LOCATION OAKVILLE CREEK BRIDGE

SLOPE EROSION - WEST END

MINUTES OF MEETING

RE: Erosion, West End, Oakville Creek Bridge
W.P. 205-~~63~~-01, Site 10

DETAIL OF GUTTER ENLARGEMENT OUTLET TO
EXPANSION JOINT STATION 281+07

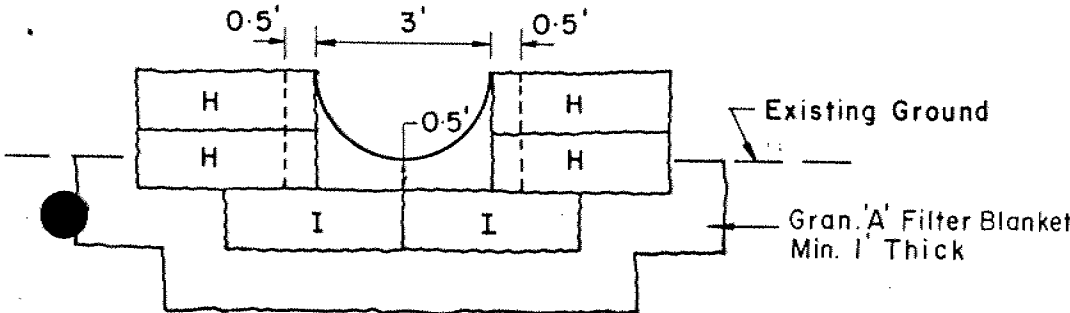
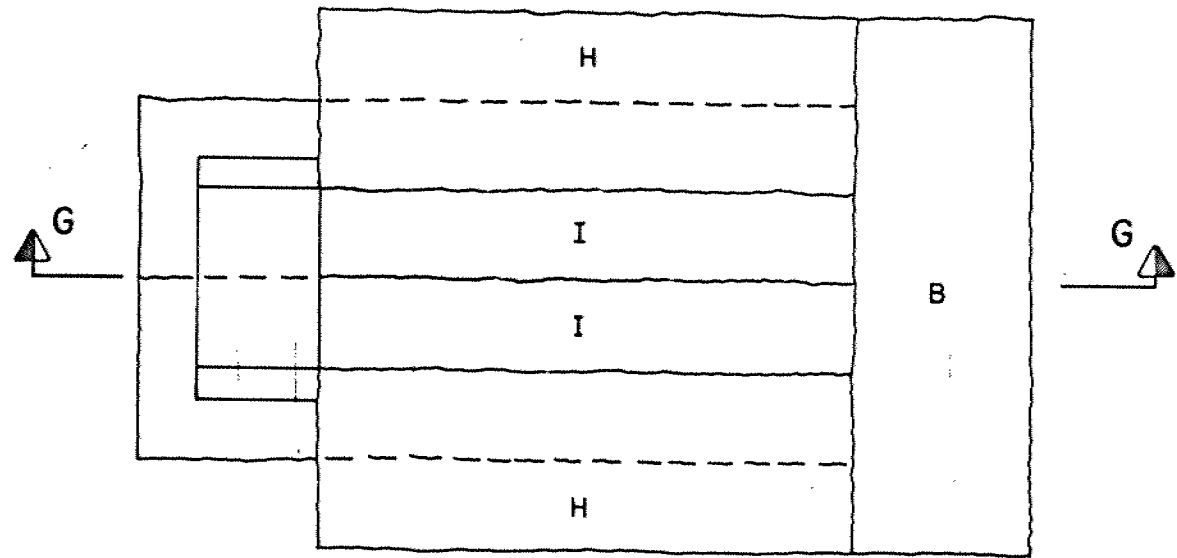
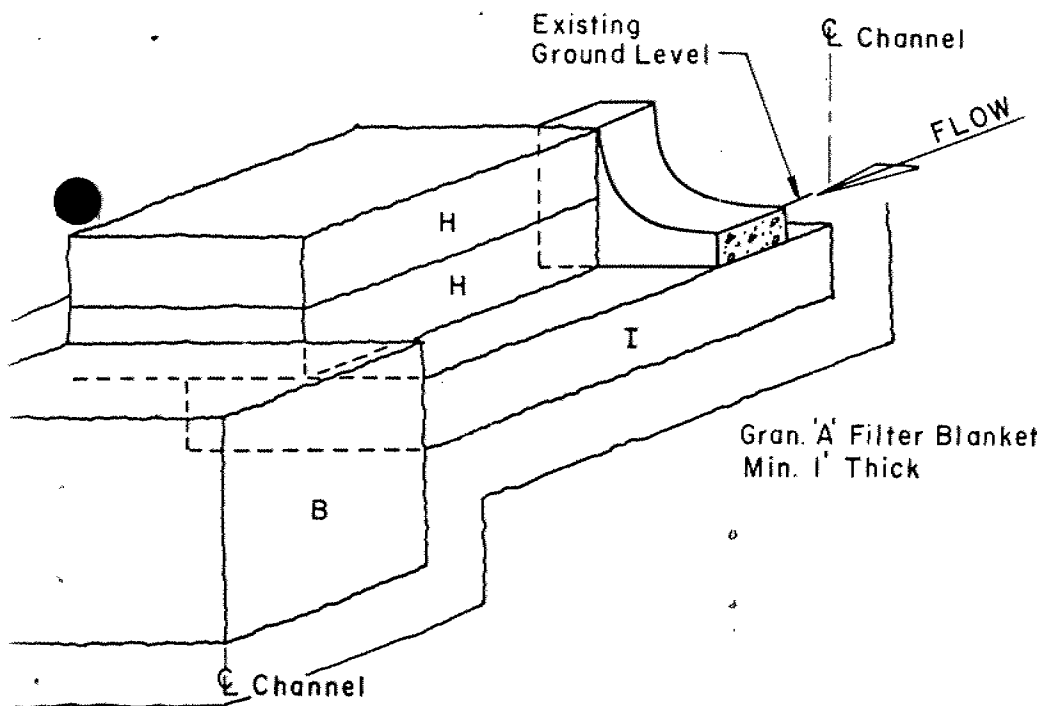
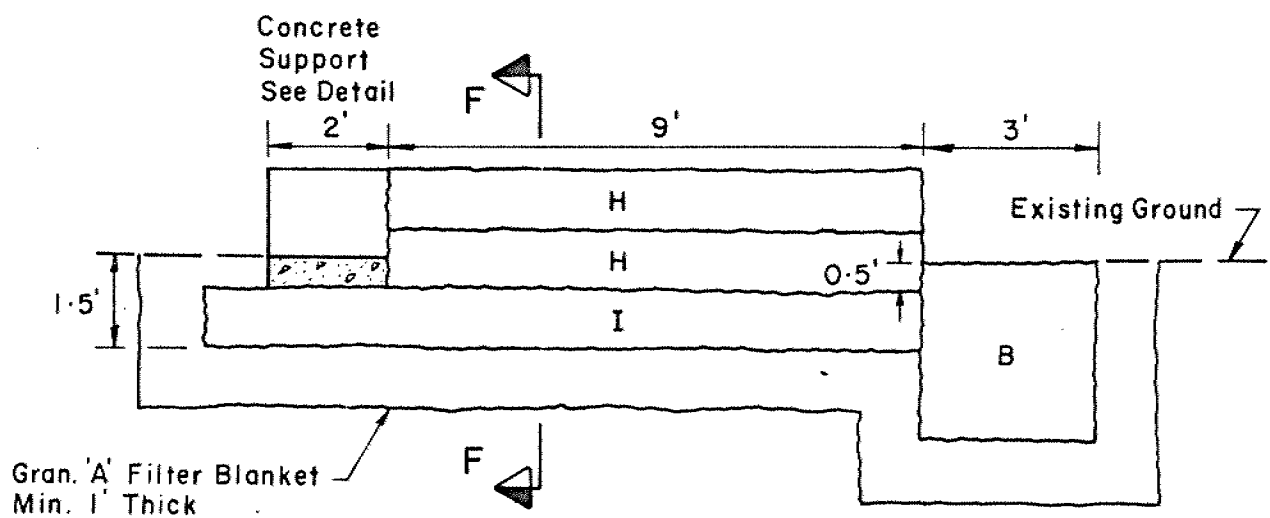
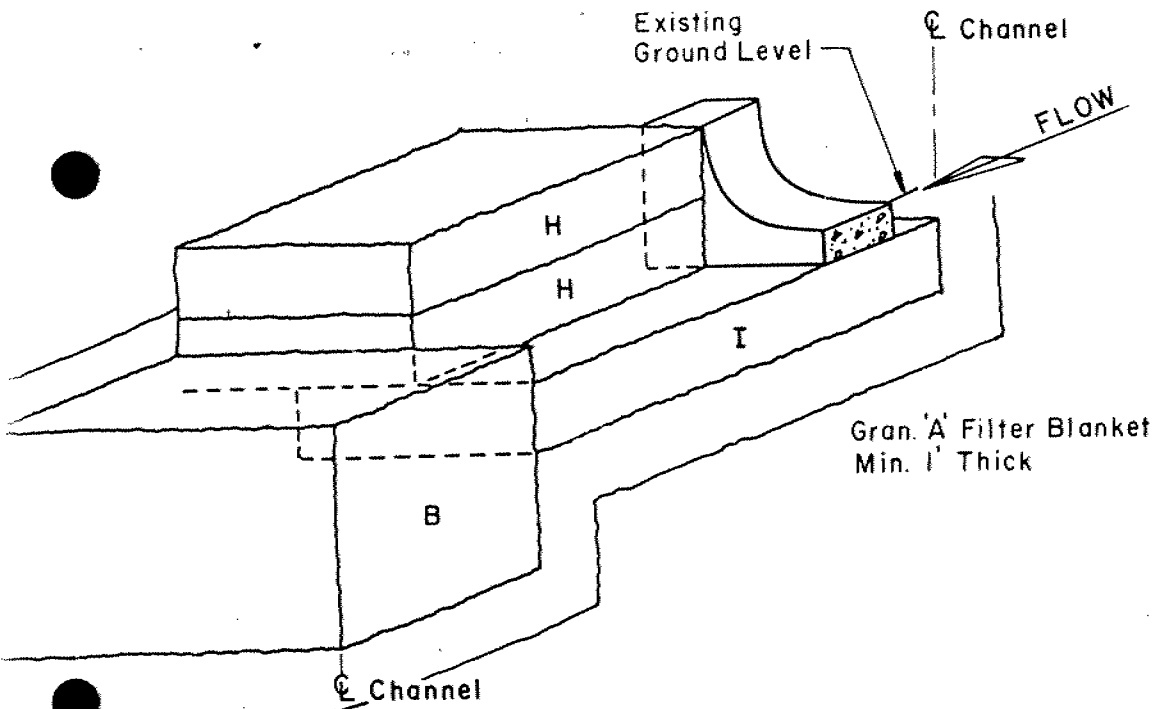
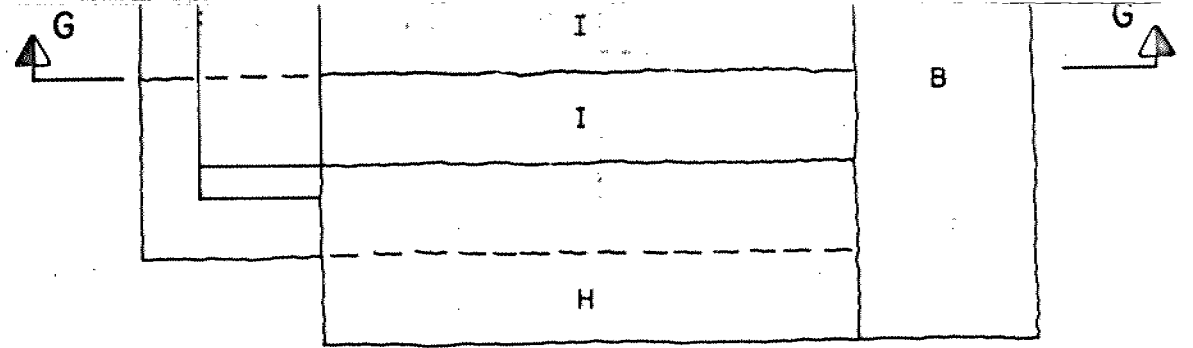
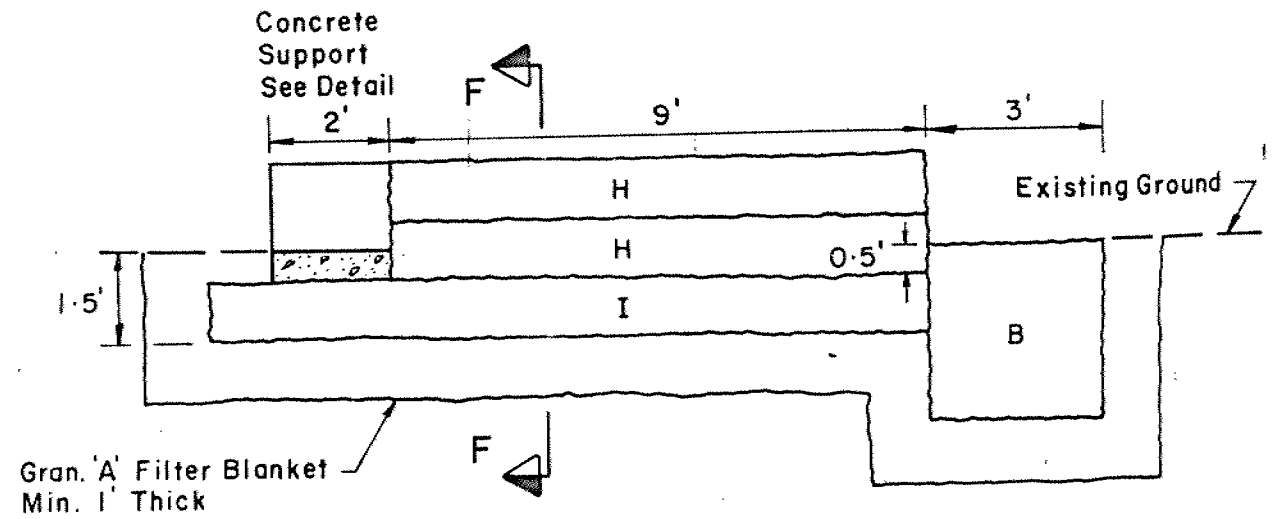
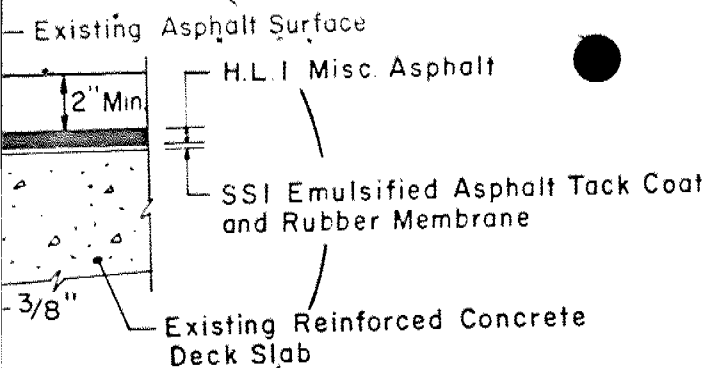
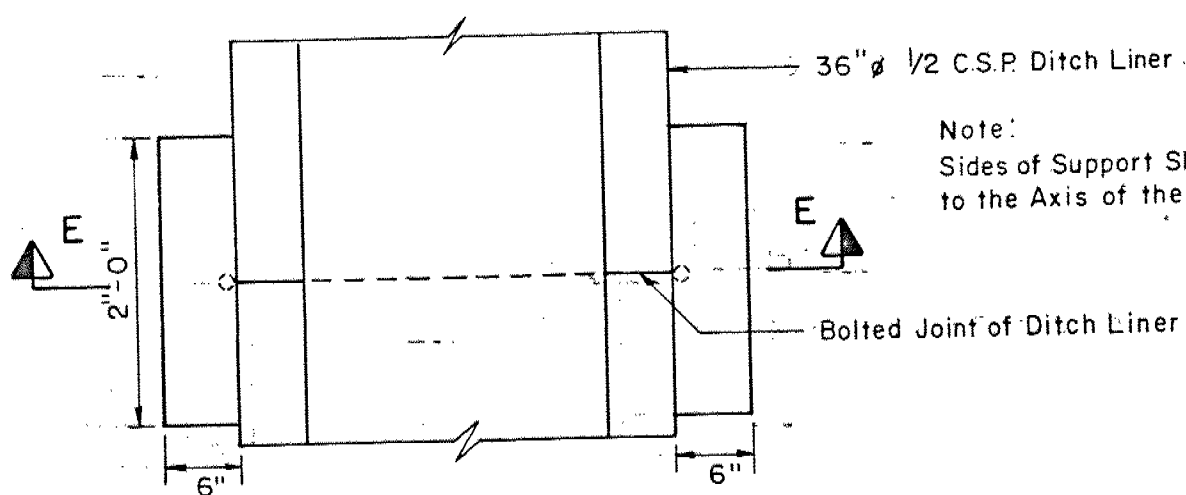
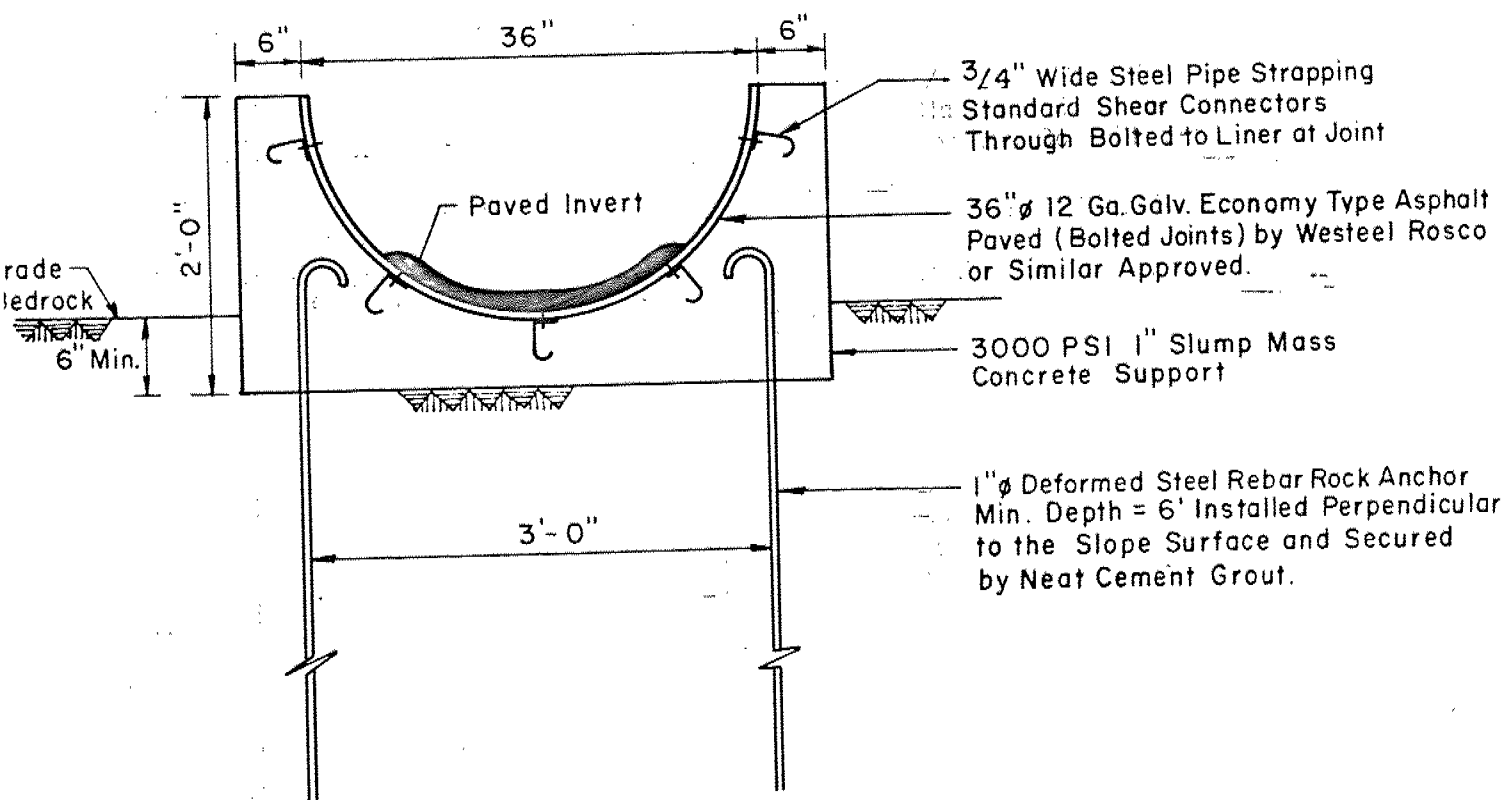
1. B. Ly reviewed the proposed drainage improvement details and agreed that the proposals will largely eliminate erosion caused by the present 24" C.S.P. but noted that erosion will continue due to surface run off from the slopes.
2. The rock anchor lengths should be increased in length from 6 ft. to 10 ft.
3. An elbow should be provided at the end of the 24" C.S.P. to direct water into the ditch lines.
4. D. Riseboro will check with Remote Sensing to establish whether photography is available at different times for this location. It may be possible to establish rates of erosion from such photography.
5. B. Ly and D. Riseboro will visit the site on May 18, to establish a method of monitoring the slope.
